CITY OF CODY
PLANNING, ZONING AND ADJUSTMENT BOARD
TUESDAY JUNE 8, 2021
CITY HALL COUNCIL CHAMBERS @ 12:00 NOON

MEETING DATE:	JUNE 8, 2021	TYPE OF ACTION NEEDED	
AGENDA ITEM:		P&Z BOARD APPROVAL:	
SUBJECT:	FINAL PLAT AND CONSTRUCTION PLANS FOR THE PINTAIL SUBDIVISION— A 12-LOT SUBDIVISION. SUB 2020-05	RECOMMENDATION TO COUNCIL:	X
PREPARED BY:	TODD STOWELL, CITY PLANNER	DISCUSSION ONLY:

<p align="center">PINTAIL MAJOR SUBDIVISION</p> <p align="center">A DIVISION OF LOT 13 WITHIN THE AMENDED GREENWING SUBDIVISION</p> <p align="center">WITHIN TRACT 40, RESURVEY T.53N., R.101W., 6TH P.M., CITY OF CODY, PARK COUNTY, WYOMING</p>	
<p>DEVELOPER / OWNER:</p> <hr/> <p>WILLIAM & RITA OVERFIELD P.O. BOX 313 CODY, WY 82414</p> <p>DOC# 2020-298</p>	 <p align="center">SAGE CIVIL ENGINEERING AND SURVEYING</p> <p align="center">2624 BIG HORN AVE. CODY, WY 82414 307-527-0915</p>
<p>JUNE 1, 2021 DRAWN BY: BF/TSB</p> <p>PROJECT # 20-016 20-016_PLPLAT_S1.DGN</p>	<p>FIELD SURVEY: FEBRUARY 2020 BY: JM FIELD BOOK: 11-12</p>

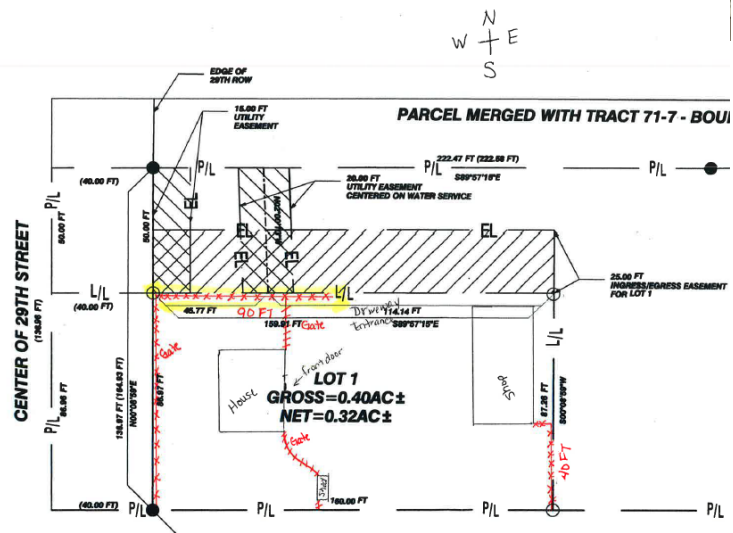
It is noted that this is a corner lot. When applying fence regulations, we typically consider the front yard to be the same as that used for setback purposes.

In this case, that means that the yard along 29th Street would be considered the front yard and the yard along Granite Court a side yard. A 6-foot fence is allowed in the side yard without the need for a height waiver. The review process requires the applicant to notify owners of the adjacent lot(s) of the request and allow them up to ten (10) days to provide comments. The applicants have indicated that they have provided both written and verbal notice to the owners of the properties to the north, east and west. Notice to the owners of the properties to the south was not initially specified as there was, and still is, some confusion as to whether the notice is to go to the lots adjacent to the subject property, or only to those adjacent to the proposed fence. To avoid any claim of inadequate notice, the applicant is in the process of notifying the property owners to the south, and will be able to report at the meeting.

1. The fence will be located approximately 26 feet from the edge of the 29th Street asphalt. This does not create the same appearance as a 6-foot fence immediately at the back of a sidewalk or at the edge of a road.
2. The property where the fence will be located is a foot or two lower than the center of 29th Street, so to some degree the taller fence height is compensating for the elevation difference.
3. The location is not within any existing or anticipated City utility easements.
4. There is approximately 11 feet between the edge of Granite Court and the fence, which combined with the distance from 29th Street allows for good sight distance at the intersection of Granite Court and 29th Street.

Provided the applicant provides notice to the property owners to the south, approve the request for a 6-foot privacy fence along the 29th Street property line.

UTILITY PLAN

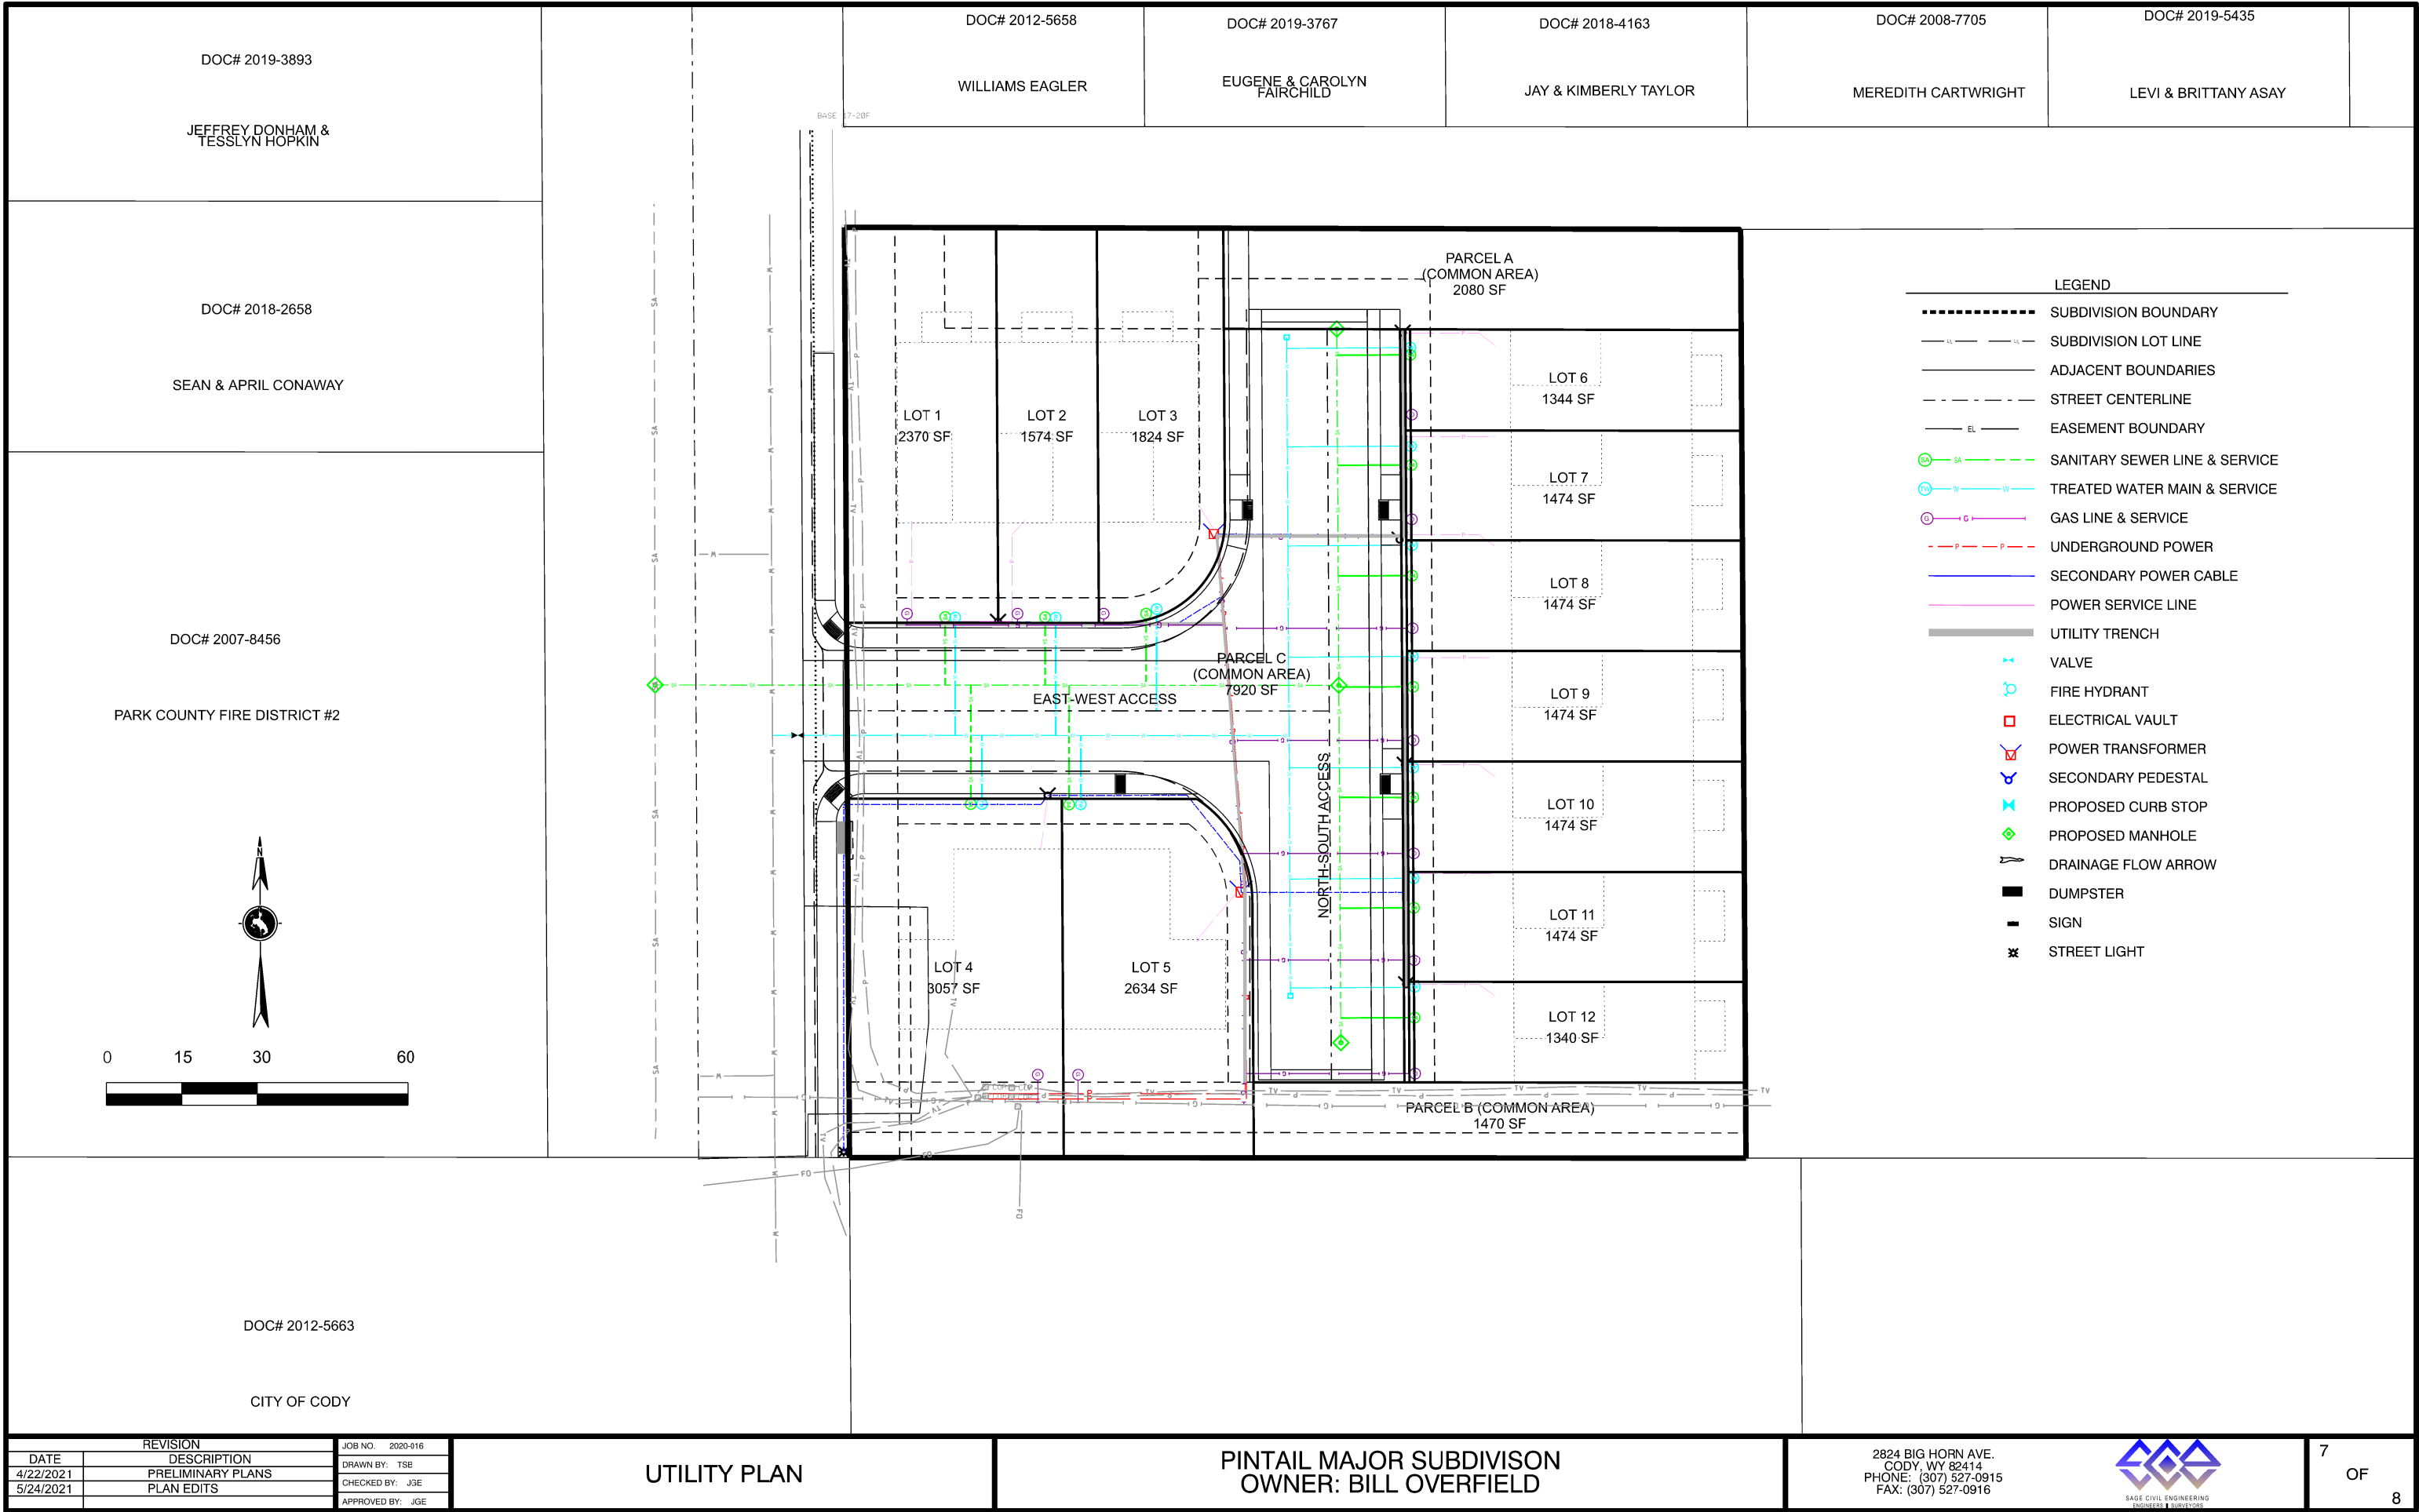
Status: Met, although the plans (routes) for 3rd party utilities are not very detailed. The contractor and engineer will need to carefully coordinate placement with the utility providers.

6. On the construction plans, note that the secondary electrical pedestals are to be given first priority for placement over other utilities, and shall be located not on the common lot line, but approximately 3 feet to the side, away from the planned driveway locations and next to the planned walkways to each front door. Adjust any utility services that conflict with the electrical pedestals.
7. Conduct all inspections, testing, and other requirements during construction, so as to comply with City Code 11-11-5-1(A).
8. The value of the subdivision improvements that will be accepted for ownership by the City must be provided by the developer to the City treasurer, so that contributed capital can be tracked.

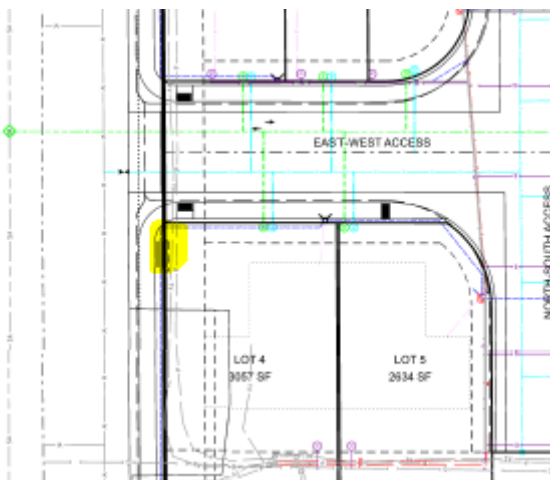
This letters serves to confirm that the USPS will provided delivery to Pintail Subdivision in Cody. the USPS agrees with the CBU location near lot 4 (see below) as illustrated in the utility plan dated 4/22/2021. Feel free to call or email me if anything else is needed.
